VF500 #1  
APRIL 1984

# SERVICE BULLETIN

## RECALL

### 1984 VF500F FUEL TANK (For California-only models)

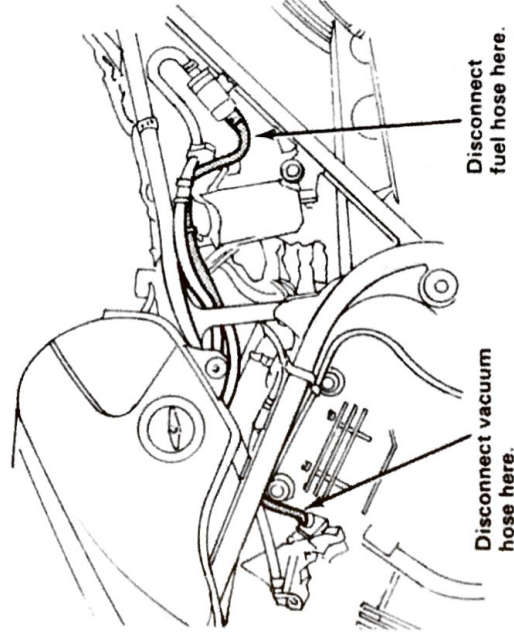
VF500Fs currently in American Honda warehouses are being modified before delivery to dealers, and will be identified by an "X" mark punched into the fuel tank's rear mounting tab, just ahead of the rubber mount (see the drawing for step 9).

9. Identify any replacement fuel tanks by making an "X" mark, using a letter punch or a small chisel, on the rear mounting tab of the tank, just ahead of the rubber mount.

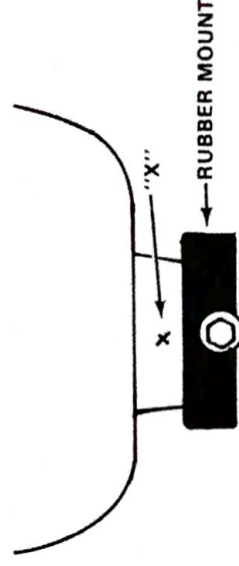
4. Turn the fuel valve to the Reserve (RES) position.

5. Connect a Mity-Vac hand vacuum pump (H/C 1230382) to the disconnected vacuum hose, then apply 12—20 mm Hg vacuum to open the fuel valve diaphragm and allow the fuel to drain.
